Subject: **USL City Environmental Services, FLD 981 932 494**
Operating Permit Application 34875-H001-002
Response to phone information request

Subject: **USL City Environmental Services, FLD 981 932 494
Operating Permit Application 34875-H001-002
Response to Meeting of May 12th on Application
Deficiency**

USL City Environmental Services (CESF) FLD 981 932 494
Operating Permit Application 34875-HO01-002
April 18, 2000

SUBJECT: **USL City Environmental Services, FLD 981 932 494**
Operating Permit Application 34875-H001-002
Response to 1st Notice of Deficiency

Figure 5.12. Container Storage Building Diagram.

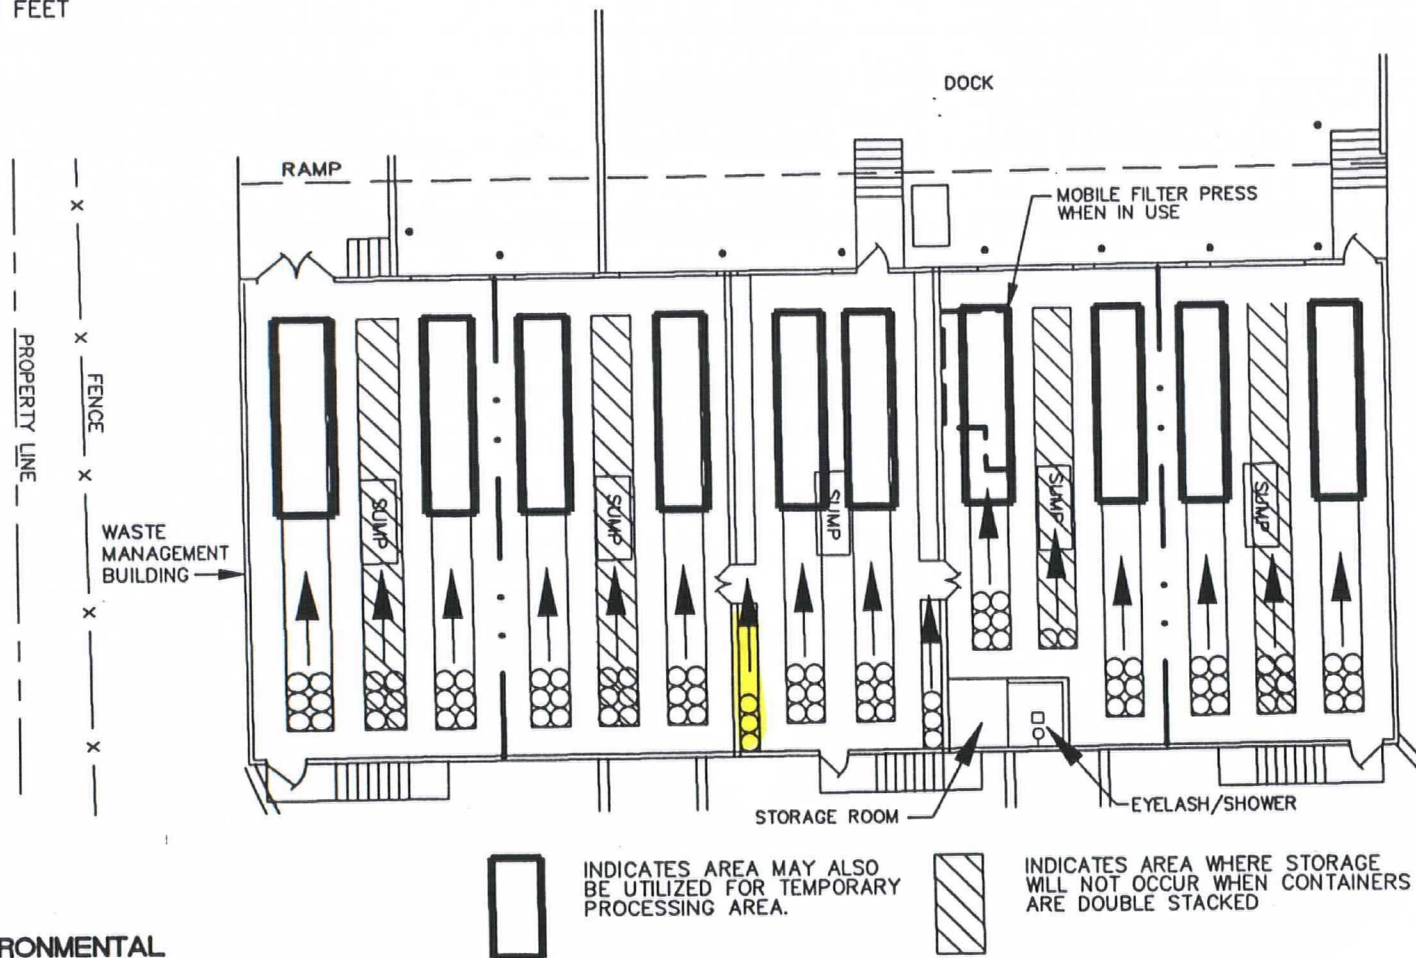
p.2 Please explain how the storage location, by waste, is indicated on Attachment 5.12. Figure 5.12 neither identifies the bays or types of waste stored in each bay.

p.2 Figure 5.12A has been added to this page. This figure provides the storage location, by waste, for each bay. Additionally, the Table of contents for Attachment 5 has been revised to include Figure 5.12A.
